Docket Number:	19-SPPE-03
Project Title:	Sequoia Data Center
TN #:	236330
Document Title:	CEC Staff's January Status Report
Description:	N/A
Filer:	Steve Kerr
Organization:	California Energy Commission
Submitter Role:	Commission Staff
Submission Date:	1/14/2021 2:41:10 PM
Docketed Date:	1/14/2021

***SEQUOIA BACKUP GENERATING
FACILITY***

Docket No. 19-SPPE-03

ENERGY COMMISSION STAFF'S JANUARY STATUS REPORT

Figure 1 shows the maximum seasonal hour-of-day NO₂ background data plotted for each hour of day and each season. The figure shows that there are significant seasonal and diurnal variabilities in the NO₂ background data.

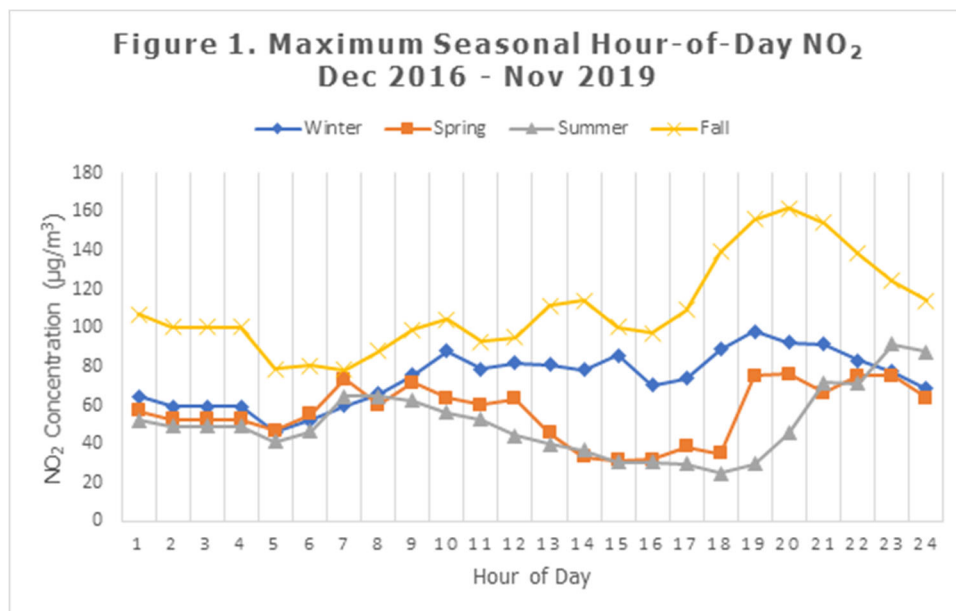
CARB questioned the temporal pairing of the project's NO₂ impacts with the NO₂ background concentrations and suggested combining the maximum modeled project impact with the maximum background to compute the total impact. Staff believes the maximum plus maximum method is overly conservative and would over-estimate project-related impacts. Because the suggested method assumes the project's maximum 1-hour NO₂ impact occurs at the exact same time the background experiences its maximum 1-hour NO₂ level, it ignores the difference between the temporal patterns of the modeling impacts and those in the ambient monitoring data. The US EPA Guideline on Air Quality Models (40 CFR 51 Appendix W⁽²⁾) states that if the diurnal or seasonal patterns of the air quality monitoring data differ significantly from the patterns for the modeled concentrations, it may be appropriate to pair the air quality monitoring data in a temporal manner that reflects these patterns (e.g. pairing by season and or hour of day). The following discussion and figures show the difference in the temporal patterns of these data.

Figure 1 and Figure 2 show a significant difference in the seasonal and diurnal patterns of the background NO₂ data and ozone data. When ozone levels peak in the afternoon, the NO₂ background levels are usually low. The comparison of Figure 1 and Figure 2 indicates it is unlikely that the project’s maximum 1-hour NO₂ impact would occur at the exact same time the background experiences its maximum 1-hour NO₂ level. Staff believes the significant difference in the seasonal and diurnal patterns of the background NO₂ data and ozone data provides enough justification for the temporal pairing of the project impacts with the background data. Staff believes using the maximum seasonal hour-of-day NO₂ background values to pair with project impacts would reasonably but still conservatively represent the worst-case total NO₂ impacts expected to occur. Therefore, staff used the maximum seasonal hour-of-day NO₂ background values in the supplemental modeling analysis.

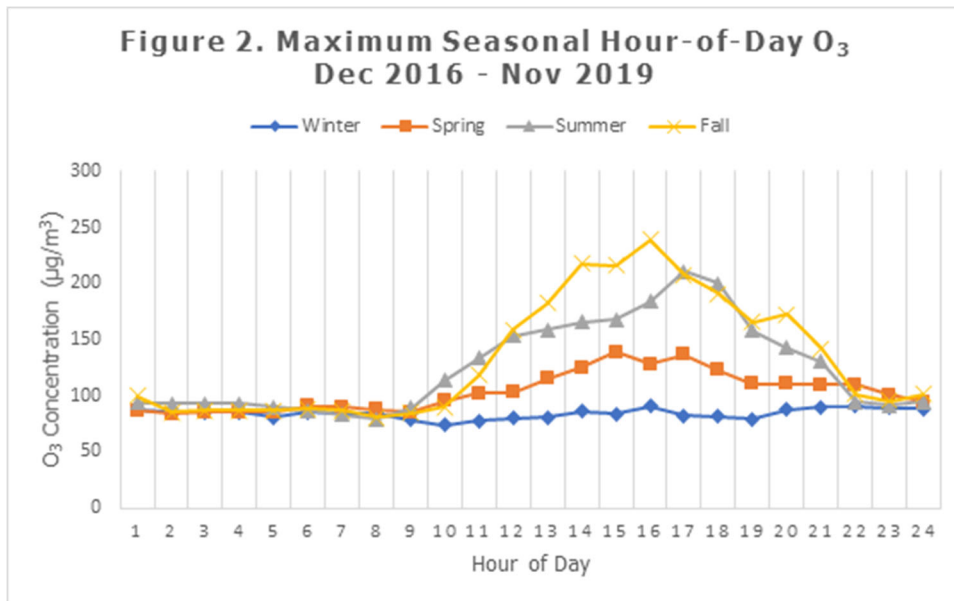
Figure 2 shows the maximum seasonal hour-of-day ozone background data plotted for each hour of day and each season. The figure shows strong seasonal and diurnal variabilities in the ozone background data. This would result in seasonal and diurnal variabilities in the modeled NO₂ impacts because ozone levels limit the conversion from NO to NO₂. However, the exact temporal pattern of the modeled NO₂ impacts is also influenced by the diurnal pattern of meteorological data.
